TOWN OF NEWBURGH
PLANNING BOARD
TECHNICAL REVIEW COMMENTS

PROJECT: HUDSON VALLEY PERSONNEL SUPPORT CENTER OF
JEHOVAH'S WITNESSES
PROJECT NO.: 2014-17
PROJECT LOCATION: SECTION 97, BLOCK 2, LOT 31.1, 30.22 & 33
PROJECT REPRESENTATIVE: MASER ENGINEERING
REVIEW DATE: 17 FEBRUARY 2015
MEETING DATE: 19 FEBRUARY 2015

Re: Hudson Valley Personnel Support Center of Jehovah's Witnesses
Tax Lot 97-2-30.1, 30.22, 33
Town of Newburgh, Orange County, New York
MC Project No. 13000398C

A2.1

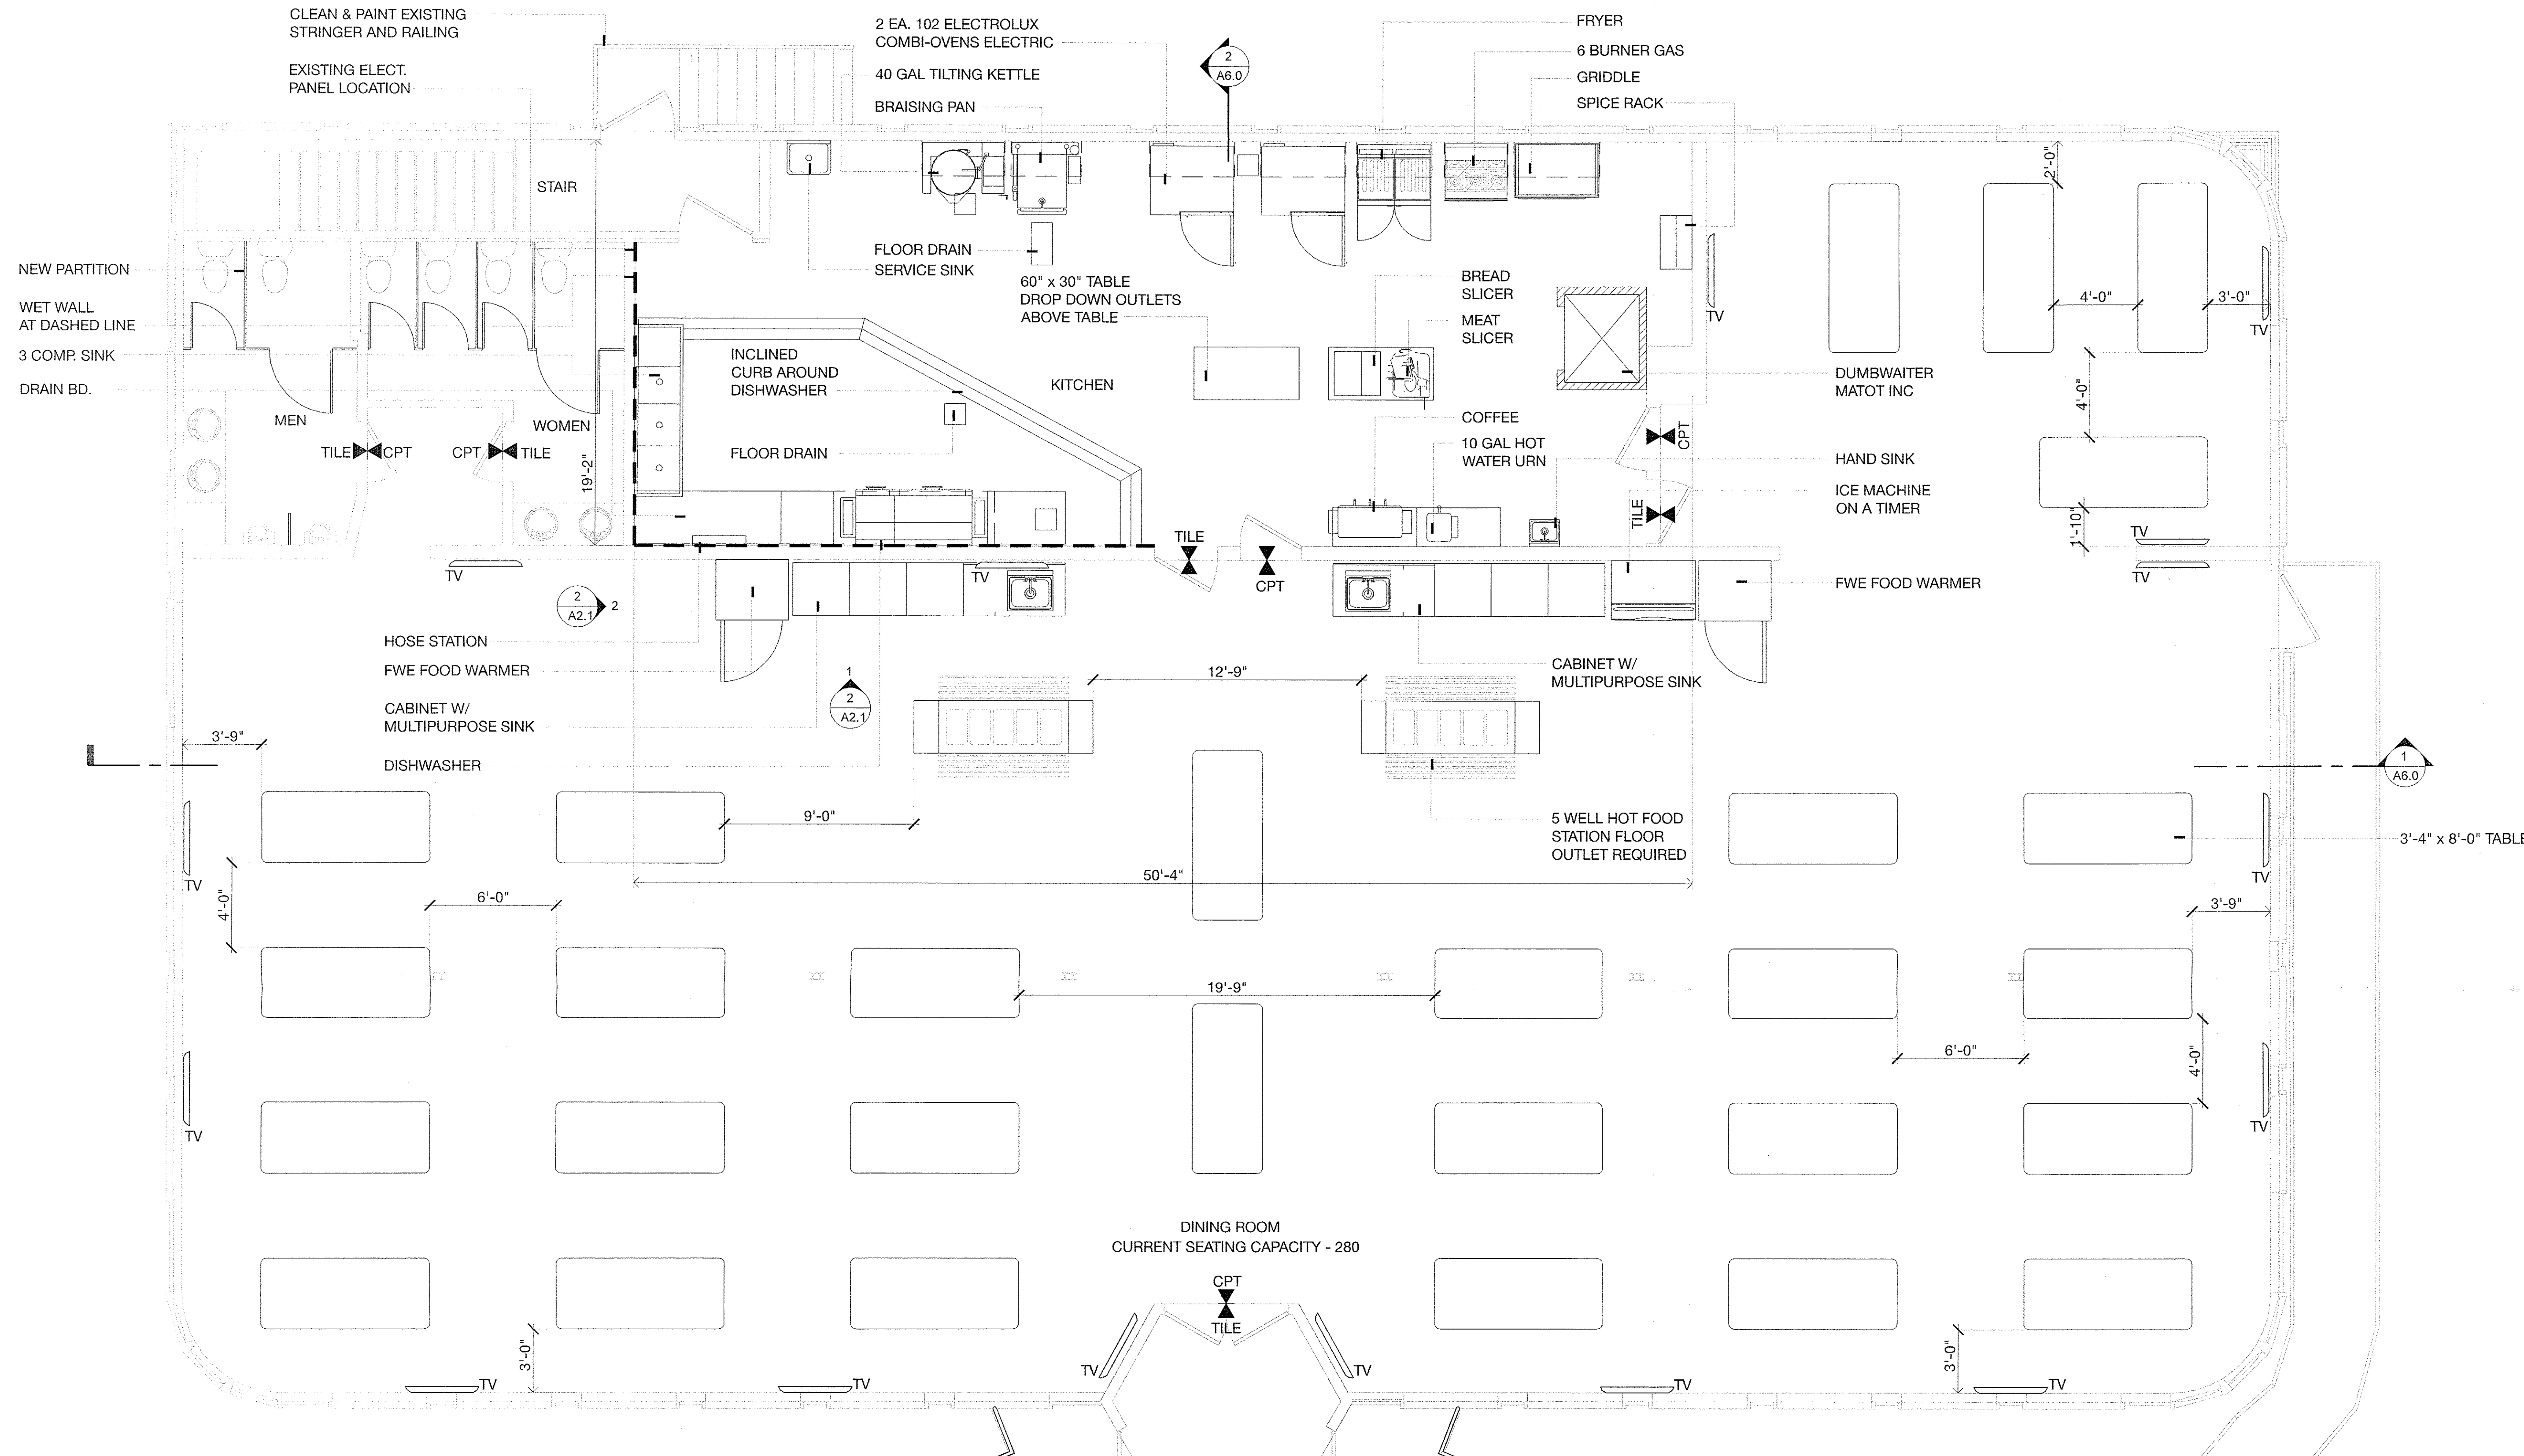
Comment 4: Parking calculation for the detached restaurant identifies "approximately 3,000 square feet of seating". Actual seating area should be depicted to confirm calculation.

Response 4: Attached to this submission is copy of the Diner Repair and Alteration Floor Plan. Based on this plan the total permitted occupancy of the dining area is 293. The parking code for restaurants allows the calculation to be generated via floor area or seating. Using the maximum permitted occupancy of 293, the Diner requires a total of 74 parking spaces (1 parking space per 4 seats). Currently there are 75 parking spaces adjacent to the Diner.
